**SERVICE BULLETIN**

SB No. 155 Issue No. 1

**INSPECTION FOR FOUL BETWEEN CANOPY SLIDE RAIL PIVOT BOLT
AND FUSELAGE SPLASH SHIELDS**

FIG 1 - CANOPY SLIDE RAIL
VIEW LOOKING FORWARD

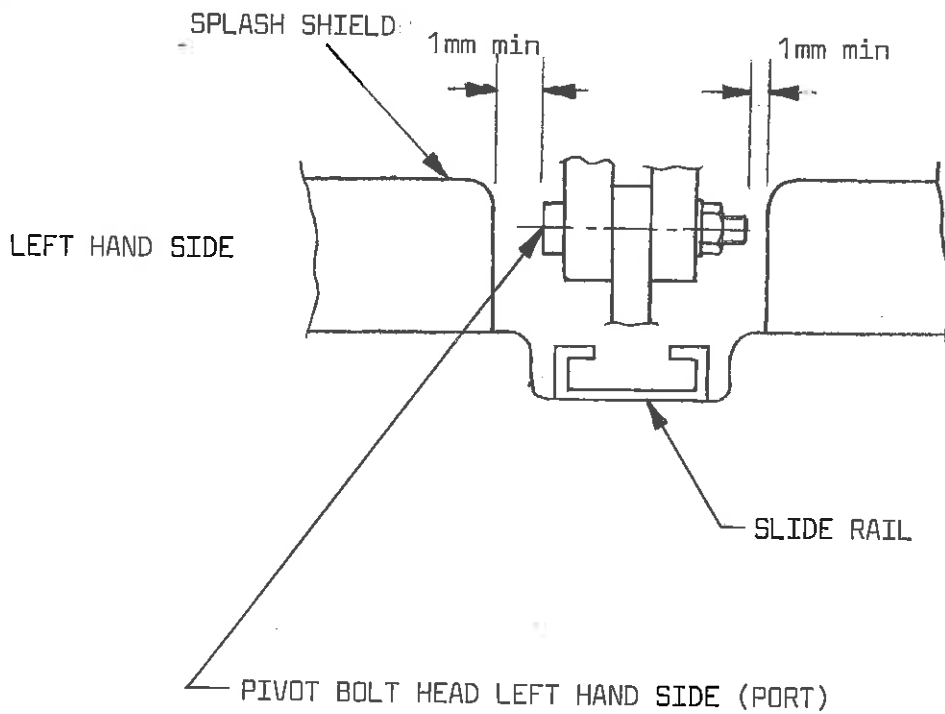
1. Ensure canopy slide rail has its head on left hand (port) side of the slider.
2. Open canopy and inspect bolt and fuselage splash shields for clearance.
3. If the clearance is greater than 1mm, ref Fig 1, no further action need be taken. If a foul has occurred or clearance is less than 1mm, a repair is to be invoked to increase splash shield clearance.
4. If applicable, repair i.a.w. Mod M843 on receipt of Mod Bulletin.
5. Annotate logbook "SB 155 complied with" on satisfactory inspection.
